**SUBJECT: SUMMARY OF CONFERENCE CALL WITH PALISADES NUCLEAR PLANT
REGARDING THE FALL 2015 STEAM GENERATOR INSPECTIONS (CAC
NO. MF6993)**

CONFERENCE CALL SUMMARY
REGARDING PALISADES NUCLEAR PLANT
FALL 2015 STEAM GENERATOR INSPECTIONS

**STEAM GENERATOR TUBE INSPECTION DISCUSSION DURING
PALISADES 2015 (RF24) OUTAGE (Preliminary Information)**

The following is a trend of the Main Condenser Off-Gas Rad-Monitor in GPD

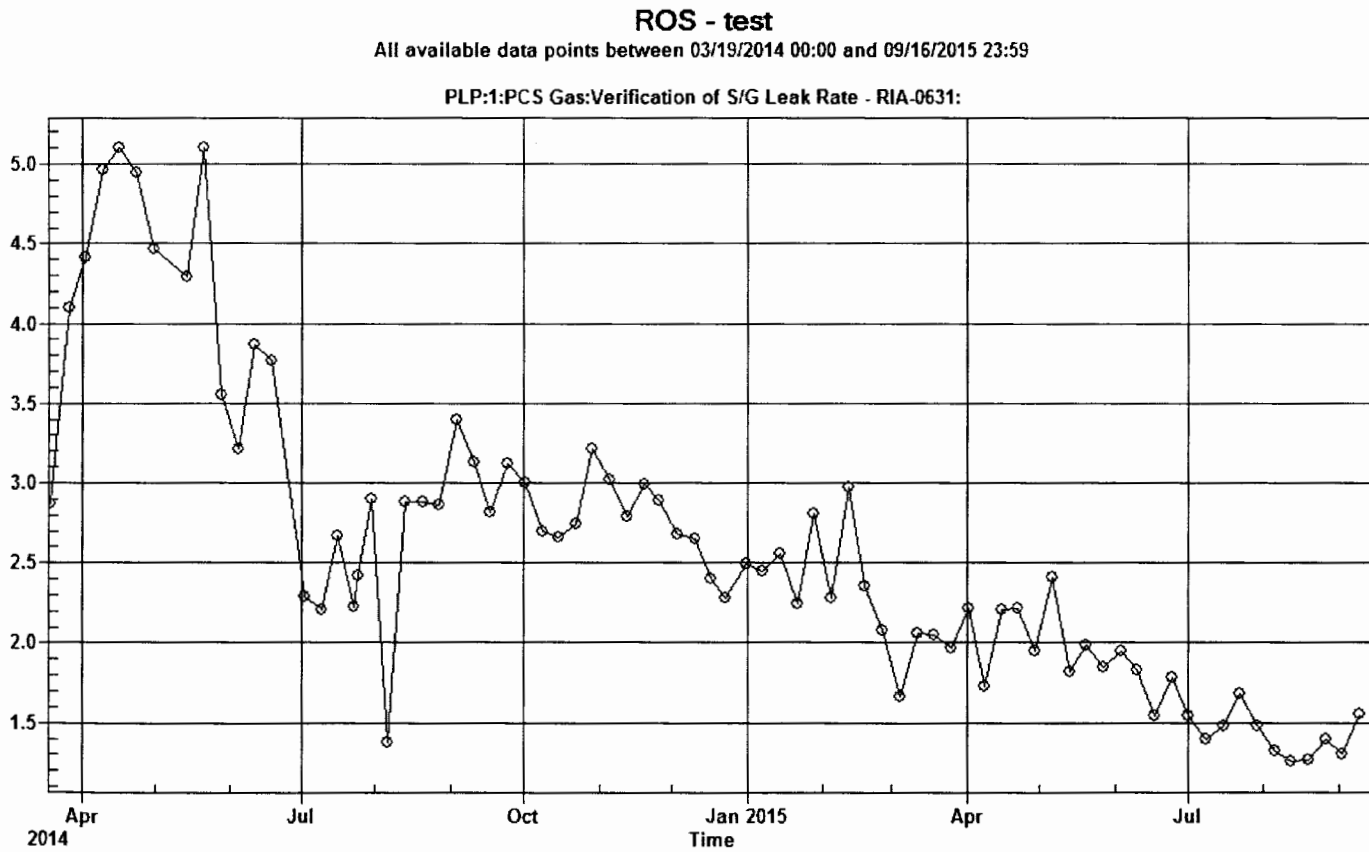
1. Discuss any trends in the amount of primary-to-secondary leakage observed during the recently completed cycle.

Refer to attached Primary to Secondary Leak Rate for Operational Cycle 24 Primary to Secondary Leak Rate graph. Leakage has been minimal all cycle.
